ADDENDUM NO. 6

DATE: January 25, 2016

Contract 15-C-00022; Hanna Pumping Station Replacement

TERMINAL BOX 1
FRONT VIEW WITH COVER REMOVED
DEDICATED TO PV1, KG1, KG2, AND PV2
(TERMINAL BOX 2—SIMILAR, BUT DEDICATED TO
PV3, KG3, KG4, AND PV4 AND GOES TO MCC
CUBICLE B5B, CB10)

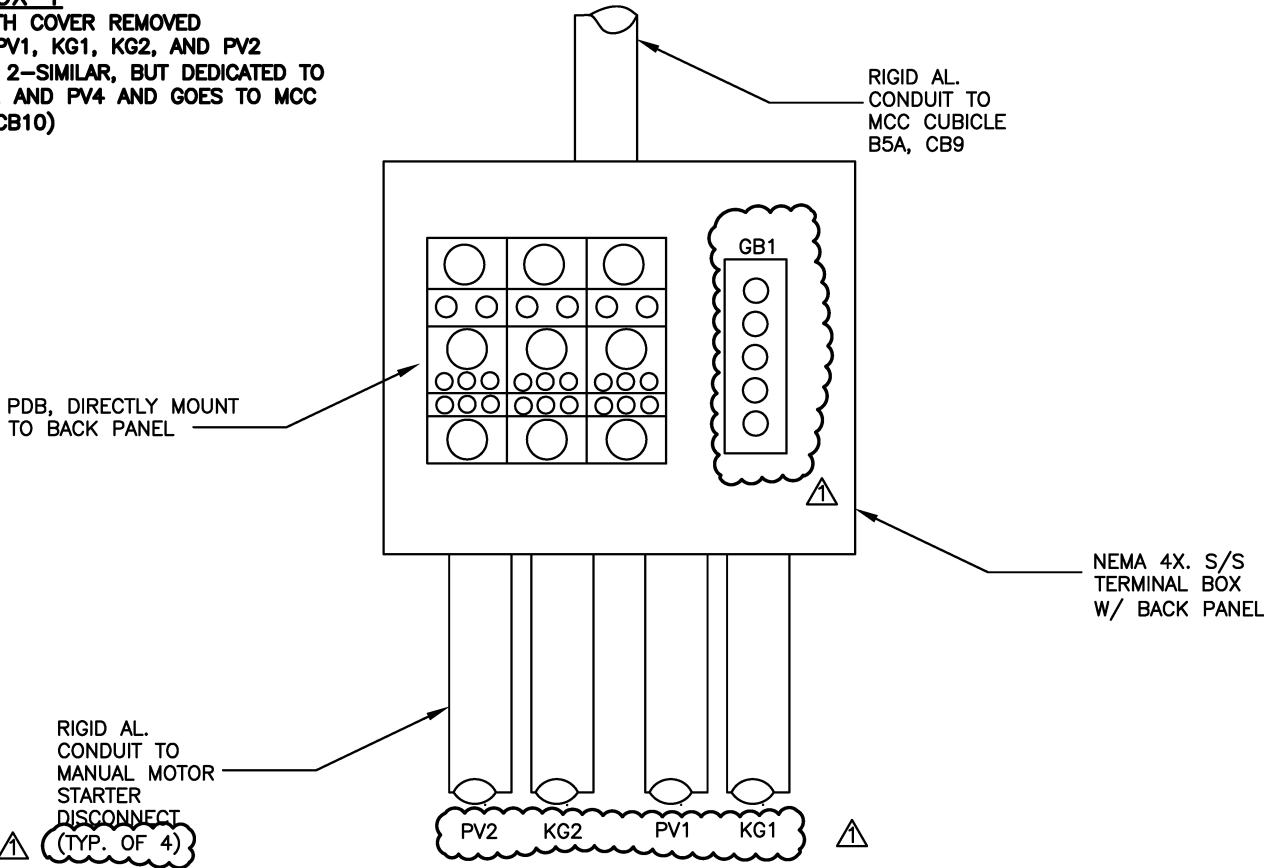
- 8 PROPOSED 3/4" CONDUIT, (3)#12 AWG. & (1)#12 GND. FROM PROPOSED TERMINAL BOX 2 TO PROPOSED MOTOR STARTER DISCONNECT (TYP. OF 4)
- ~~9 PROPOSED 3/4" CONDUIT, (3)#12 AWG. & (1)#12 GND. (FROM PROPOSED MOTOR STARTER DISCONNECTS PV3 TO PROPOSED TERMINAL BOX 2)~~

- ~~10 PROPOSED 3/4" CONDUIT, (3)#12 AWG. & (1)#12 GND. (FROM PROPOSED MOTOR STARTER DISCONNECTS PV4 TO PROPOSED TERMINAL BOX 2)~~
- 11 PROPOSED NEMA 4 MANUAL MOTOR STARTER DISCONNECTS, TYPICAL OF 8
